REGIONAL REVIEW NOTICE

ARC REVIEW CODE: R1610102

Name of Proposal: Spring and 8th

SPRING AND 8TH DRI
City of Atlanta
Natural Resources Division Review Comments
October 4, 2016

DRI SITE PLAN

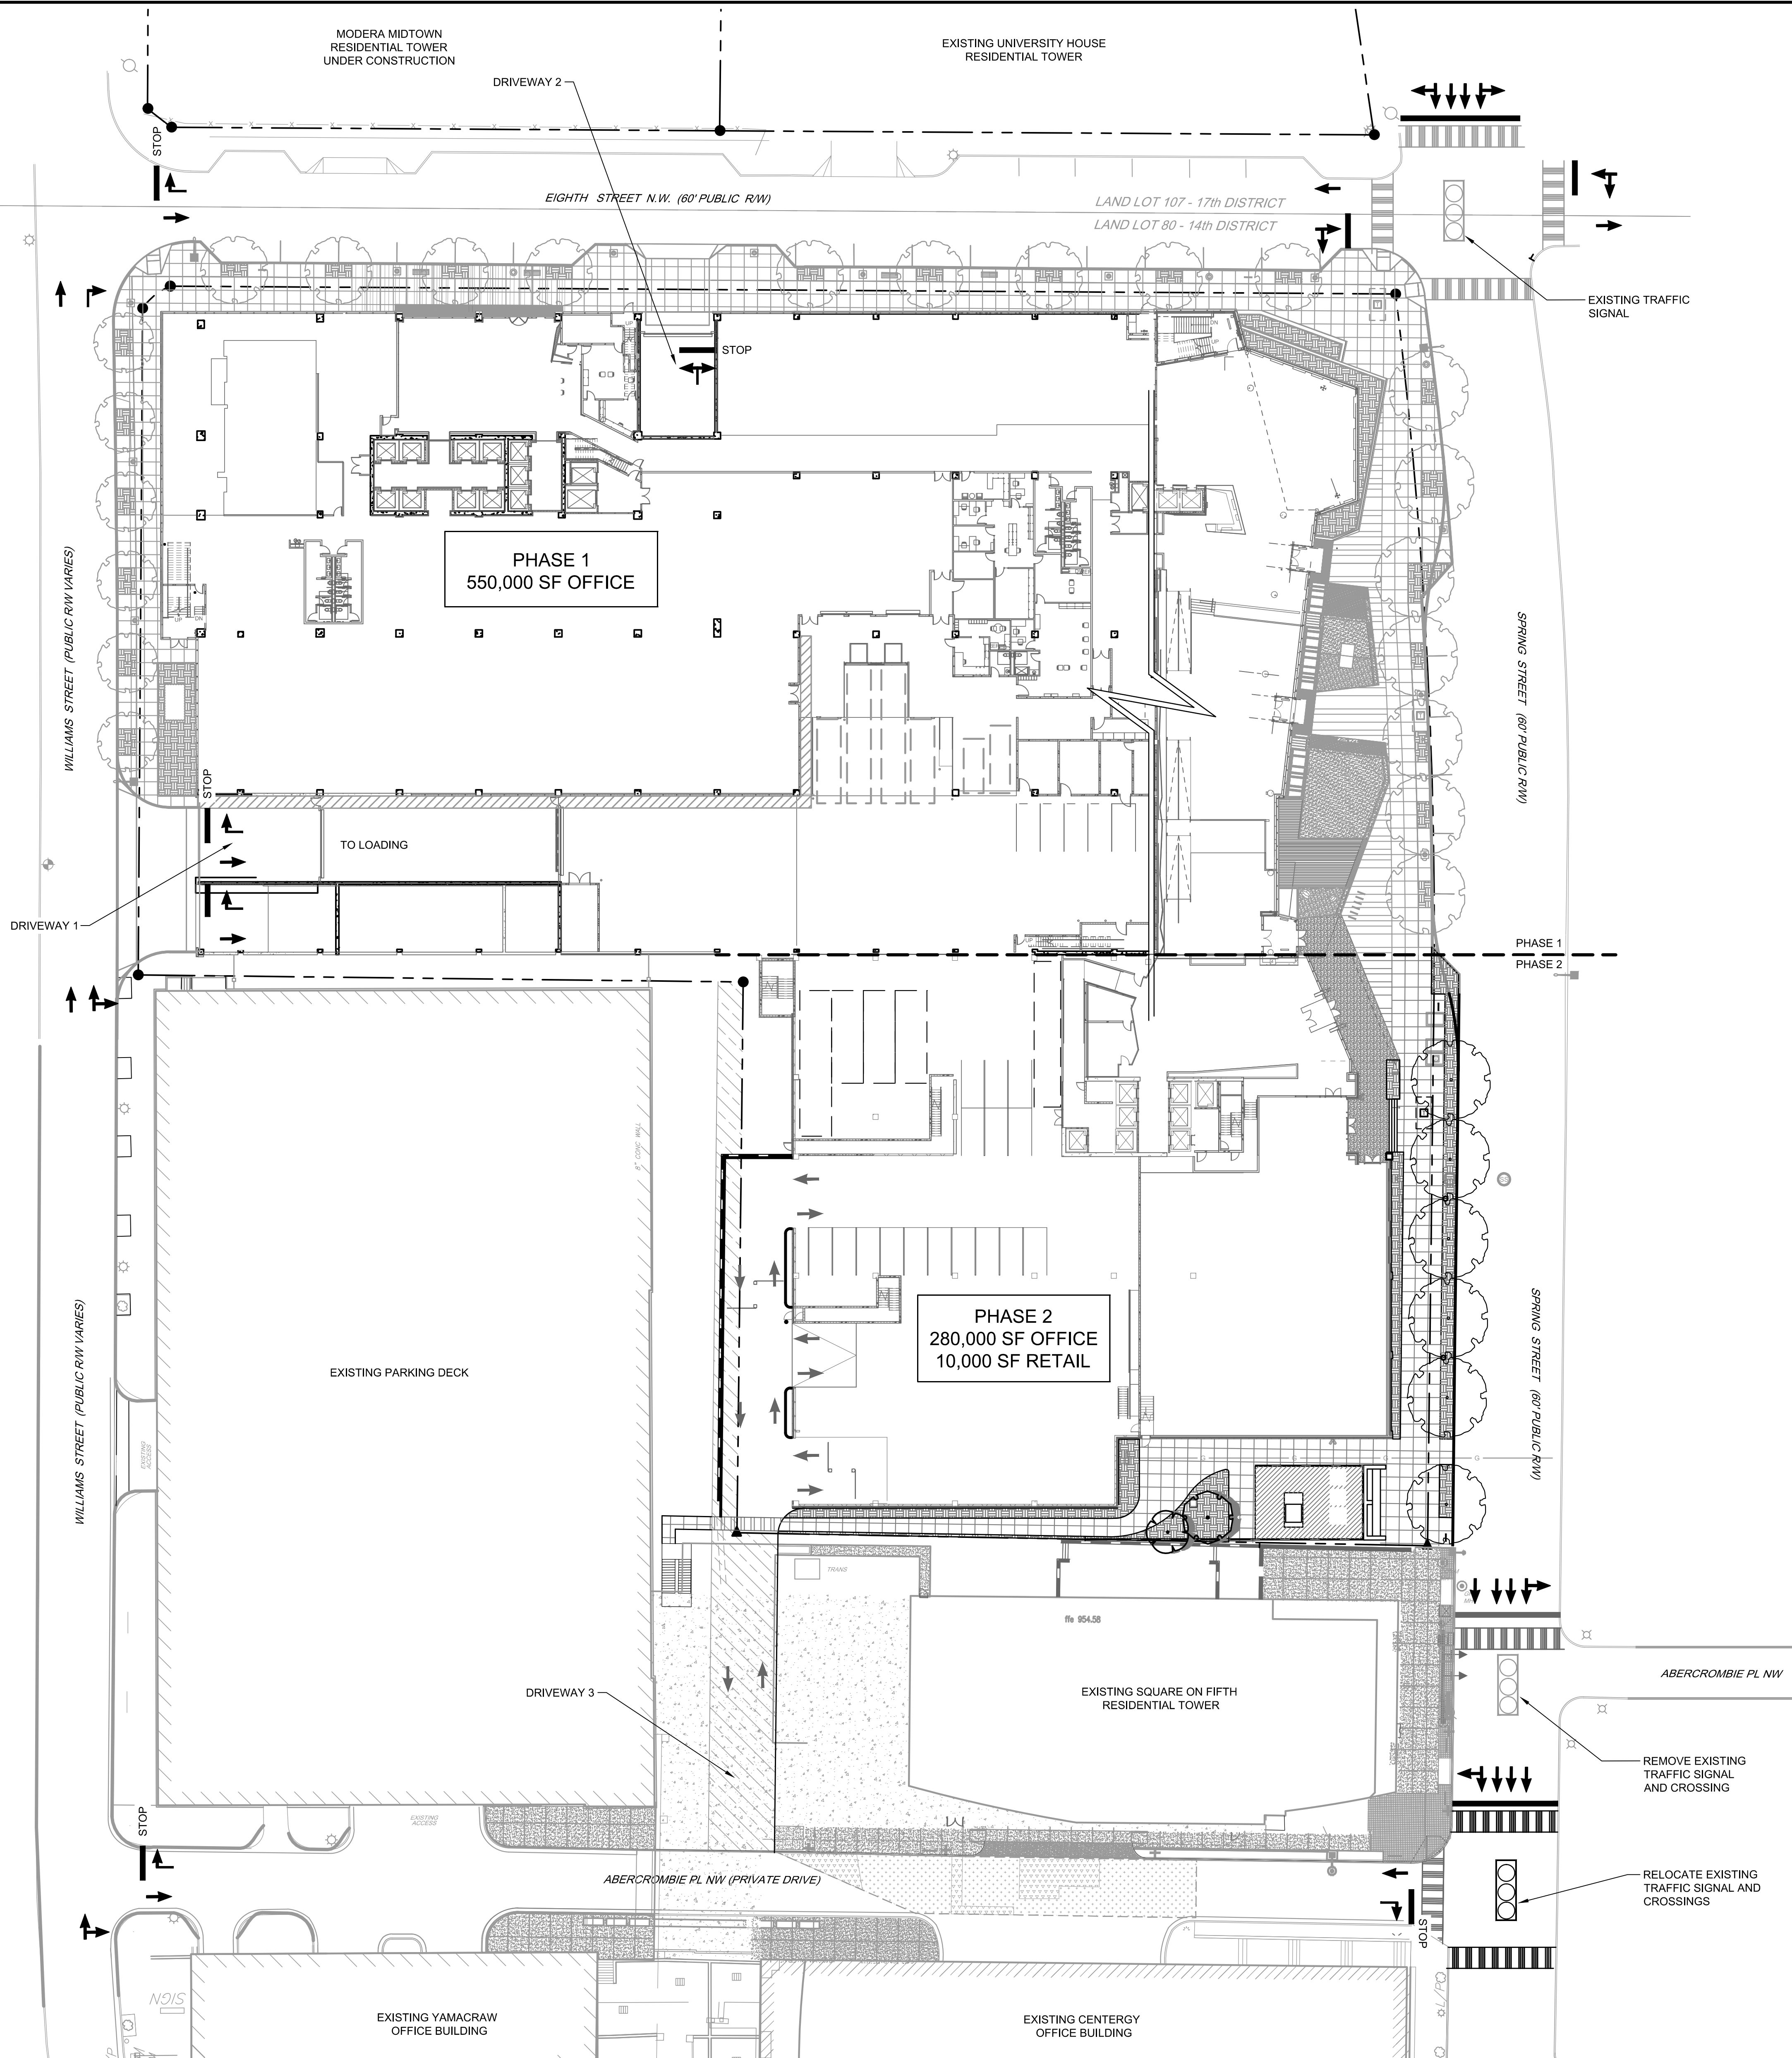
This is a redevelopment project which encompasses the entire block of the Southeast corner of Spring Street and 8th Street. Vehicular and pedestrian access is provided through the site. Vehicular access from Abecrombie Place is proposed to align with existing access ways on adjacent parcels.

This is a redevelopment project which encompasses the entire block of the Southeast corner of Spring Street and 8th Street. Pedestrian facilities such as sidewalks and walkways along the perimeter of the development are being proposed. City of Atlanta noted a dedicated bicycle lane project programmed by the City to commence 2018 along Spring Street adjacent to the site.

Vehicular traffic lanes internal to the site are identified as well as loading areas for trucks serving the retail space. These are sidewalk facilities adjacent to drive lanes and designated bike racks. There is no differentiation between vehicular and bicycle and pedestrian travel lanes noted on the plans.
